ADMINISTRATIVE AMENDMENT PD-97-056

ADMINISTRATIVE AMENDMENT
LEE COUNTY, FLORIDA

**BRENTWOOD
PELICAN LANDING
ADMINISTRATIVE AMENDMENT
PREPARED FOR: WCI COMMUNITIES, L.P.**

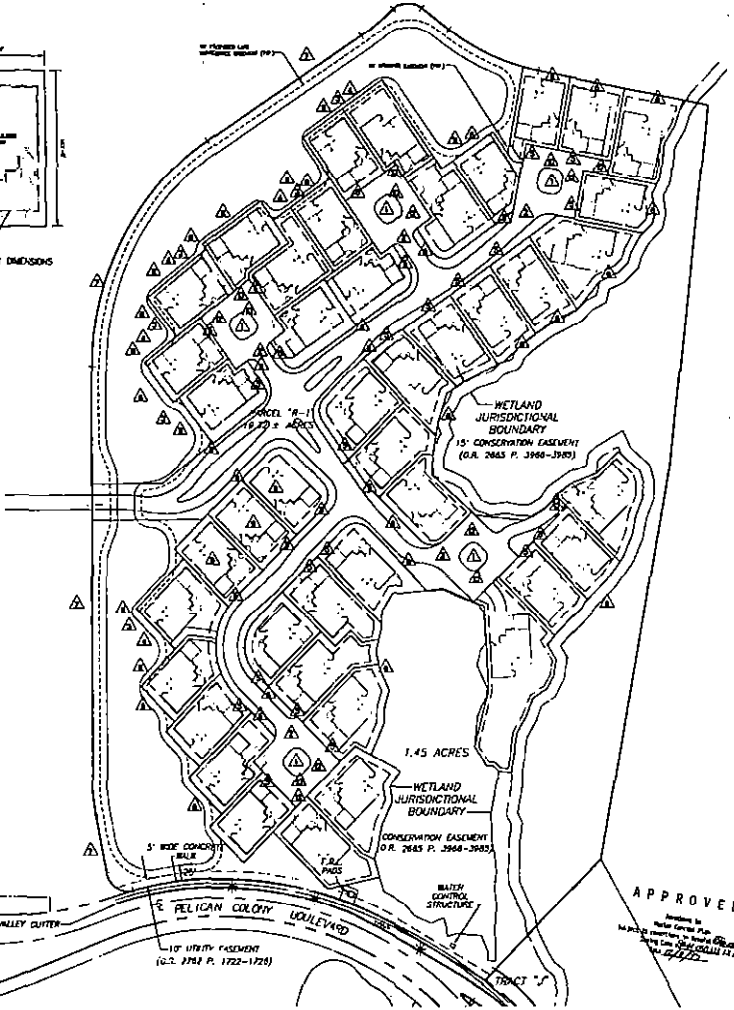
- 1) Deviation from LDC Section 10-296(k)(1) which requires that a cul-de-sac be
constructed with a minimum outside diameter of 90 feet diameter to permit an outside
diameter of 85 feet [Deviation No. 1 on approved plan];
- 2) Deviation from LDC Section 10-296(k)(3) which requires that the transition from the
cul-de-sac pavement to the regular approaching pavement be in compliance with
Section 10-714 to permit a transition as depicted on the approved plan [Deviation No.
2 on approved plan];

- 3) Deviation from LDC Section 10-328(a) which requires a 20 foot wide lake maintenance easement to allow a 10 foot wide maintenance easement as shown on the approved plan [Deviation No. 3 on approved plan];

- 4) Request to modify Condition 11.a of resolution Z-94-014 to reduce the minimum required lot width of 40 feet to a width of 15 feet for those lots shown on the approved plan [Deviation No. 13 on approved plan];

- 5) Request to modify Condition 11.b of resolution Z-94-014 to:
 - a) Reduce the minimum setback for a principal structure from a water body from the required 15 feet to 10 feet where a bulkhead is proposed [Deviation No. 4 on approved plan];

- b) Reduce the minimum setback for a principal structure from a street from the required 15 feet to 10 feet for those units with side entry garages [Deviation No. 5 on approved plan];

- c) Reduce the minimum setback for a principal structure from the rear property line from the required 15 feet to 10 feet [Deviation No. 6 on approved plan];

- 6) Deviation from LDC Section 10-329(e)(1)(a) from the minimum required setback for a body of water from the street right-of-way for a local street from the required 25 feet to 15 feet [Deviation No. 7 on approved plan];

- 7) Deviation from LDC Section 10-355(a)(1) which requires 10 foot wide utility easements on each side of the street right-of-way to permit the required easements to be located within the street right-of-way [Deviation No. 8 on approved plan];

- 8) Deviation from LDC Section 10-254(b) which discourages double frontage lots to permit double frontage lots as shown on the approved plan [Deviation No. 9 on approved plan];

- 9) Deviation from LDC Section 10-254(c) which requires that side lot lines be radial to curved street lines to permit side lot lines as shown on the approved plan [Deviation No. 10 on approved plan];

- 10) Deviation from LDC Section 10-329(e)(4) which requires that excavations for water retention be sloped at a ratio of not greater than 4:1 and 2:1 to permit bulkheads as shown on the approved plan [Deviation No. 11 on approved plan];

- 11) Deviation from LDC Section 34-2221(4)(c) which allows for irregularly shaped lots on cul-de-sacs with nonparallel side lot lines to have a minimum street frontage less than the required provided that the side lot lines are radial to the center point of the cul-de-sac with a minimum angle of 45 degrees to permit the lot widths shown on the approved plan [Deviation No. 12 on approved plan];

2. The terms and conditions of the original zoning resolution and any amending resolutions remain in full force and effect.
3. Deviation from LDC Section 10-328(a) (listed as #3 on the approved plan) is approved provided written confirmation of "no objection" is provided by the entity responsible for the maintenance of the lake.

4. Deviation from LDC Section 10-329(e)(1)(a) (listed as #7 on the approved plan) is approved provided that the street is constructed with Type "F" curb and gutter on the side adjacent to the lake and adequate protection for wayward vehicles is provided. The protection devices will be subject to review and approval by the Development Services Division.

5. Deviation from LDC Section 10-355(a)(1) (listed as #8 on the approved plan) is approved provided that the streets will be private, the design of the streets is acceptable to the appropriate Homeowners Association, and the responsibility for maintenance of the streets will rest with the Homeowners Association. In addition, any utility lines located beneath the pavement shall be constructed of heavier than standard material.

6. Deviation from LDC Section 10-254(b) (listed as #9 on the approved plan) is approved provided that the Development Order plans and recorded plat specifically state that access to the double frontage lots will be from the "internal" road only, and not from the "main entrance" road.

7. Deviation from LDC Section 10-329(e)(4) (listed as #11 on the approved plan) is approved provided that the maximum 4:1 slope will begin at a point no lower than the dry season water table elevation line, and extend to a minimum of 4 feet below the dry season water table elevation line.
